<b>Title - Sujet</b> Purchase of Shelving & Installation	
<b>Solicitation No. - N° de l'invitation</b> 5X001-170733/A	<b>Amendment No. - N° modif.</b> 001
<b>Client Reference No. - N° de référence du client</b> 5X001-170733	<b>Date</b> 2017-11-09
<b>GETS Reference No. - N° de référence de SEAG</b> PW-\$\$HN-465-73690	
<b>File No. - N° de dossier</b> hn465.5X001-170733	<b>CCC No./N° CCC - FMS No./N° VME</b>
<b>Solicitation Closes - L'invitation prend fin</b> <b>at - à 02:00 PM</b> <b>on - le 2017-12-18</b>	<b>Time Zone</b> <b>Fuseau horaire</b> Eastern Standard Time EST
<b>F.O.B. - F.A.B.</b> <b>Plant-Usine:</b> <input type="checkbox"/> <b>Destination:</b> <input checked="" type="checkbox"/> <b>Other-Autre:</b> <input type="checkbox"/>	
<b>Address Enquiries to: - Adresser toutes questions à:</b> Nadeau, Alexandra	<b>Buyer Id - Id de l'acheteur</b> hn465
<b>Telephone No. - N° de téléphone</b> (819) 420-2859 ( )	<b>FAX No. - N° de FAX</b> (819) 953-4944

This amendment 001 is being raised to remove the optional goods and add them to the main contract and to address questions submitted by potential bidders;

Procurement and Installation of Shelving at 1770 Pink Road Records Center

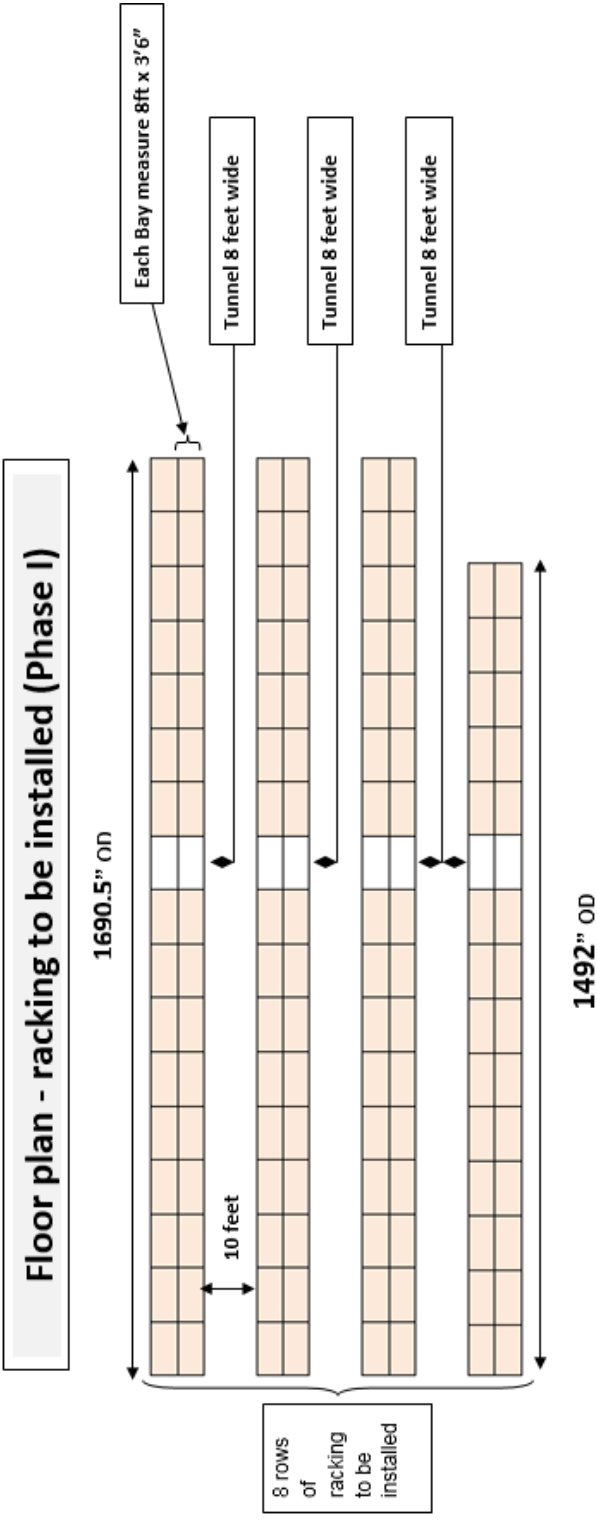
**Description of drawing:**

In total 8 rows of racking to be installed including:

- 6 rows of racking, each row consists of 50 bays and measure 1690.5" OD.
- 2 rows of racking, each row consists of 44 bays and measure 1492" OD.
- Each row of racking consists of three 3 levels of bays except for the tunnels that consists of two levels of bays.
- Each row of racking is 18 feet tall.
- Each Bay measure 8 feet x 3'6"
- Each row of racking has an 8ft tunnel (size of a bay) for Forklift passage.
- 1.5 per frame in back-to-back row - 12" ROW SPACERS – GALVANIZED.
- Each two back-to-back rows are separated by a distance of 10 feet.

Floor plan - racking to be installed (Phase II)

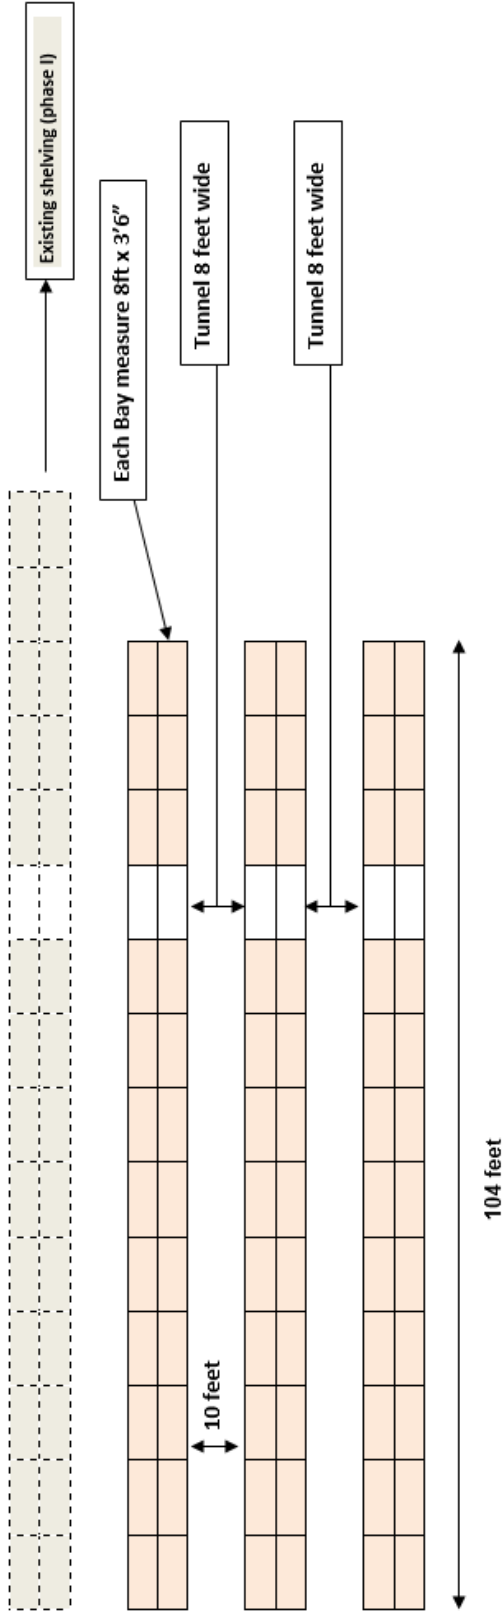
Description of Phase I floor plan racking:

In total 3 rows of racking to be installed including:

- Each row consists of 38 bays and measures 104 feet.
- Each row of racking consists of three 3 levels of bays except for the tunnels that consists of two levels of bays.
- Each row of racking is 18 feet tall.
- Each Bay measure 8 feet x 3'6"
- Each row of racking has an 8ft tunnel (size of a bay) for Forklift passage.
- 1.5 per frame in back-to-back row - 12" ROW SPACERS – GALVANIZED.
- Each two back-to-back rows are separated by a distance of 10 feet.
